INFORMATION TO BIDDERS
for

HARRIS HARBOR ANODE INSTALLATION
Contract No. DH21-036

Date Issued: April 8, 2021

CONTRACTOR STAGING AREA
10 PARKING SPACES AT NORTH END OF TIDAL GRID

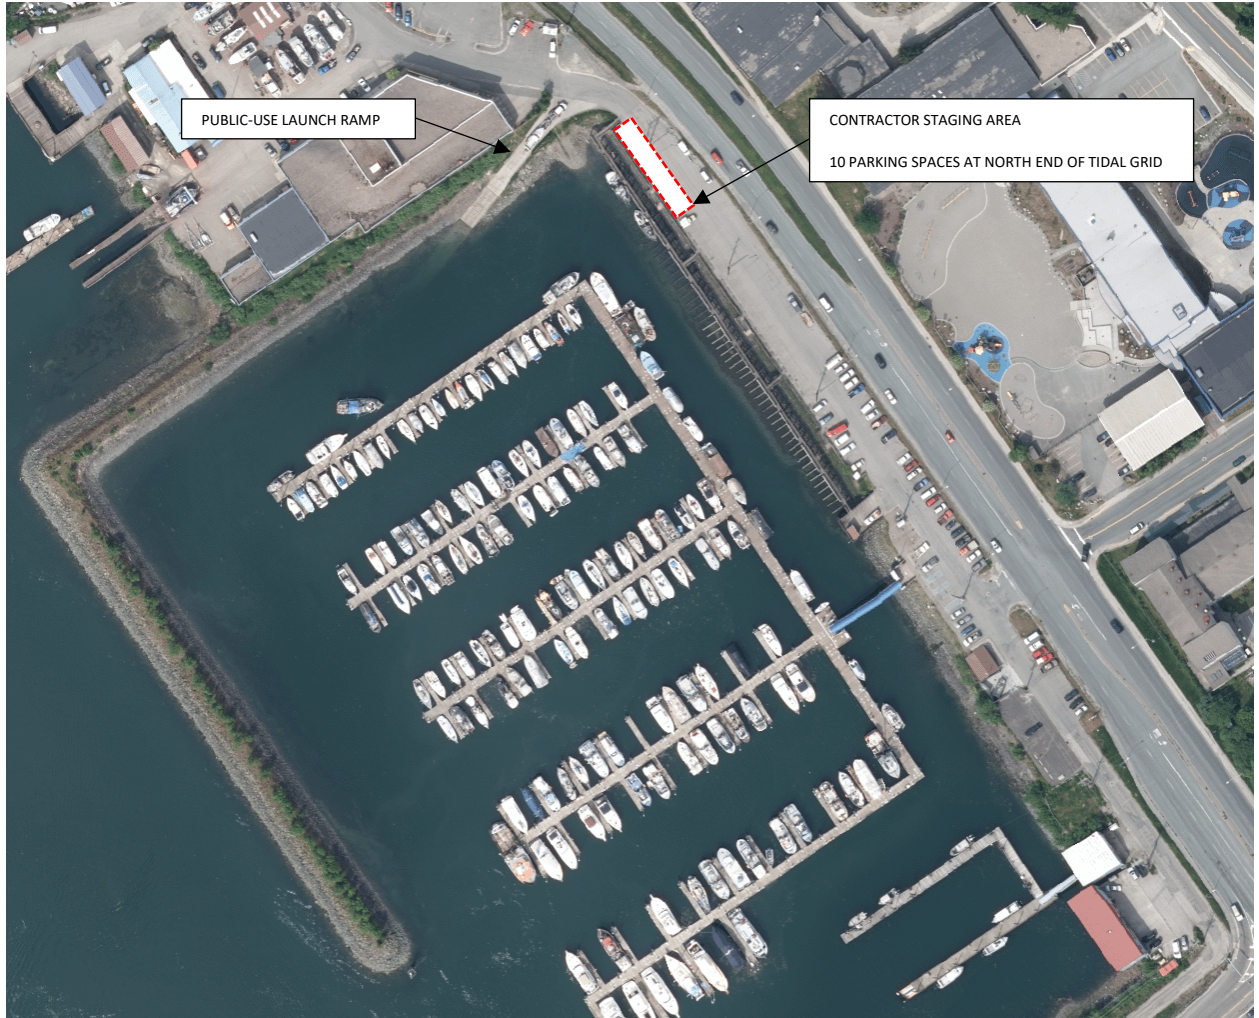
Question: “There is no laydown yard specified in the drawings? Will there be a laydown yard on site that the contractor can utilize for his equipment and materials?”

Response: Yes, see attached drawing.
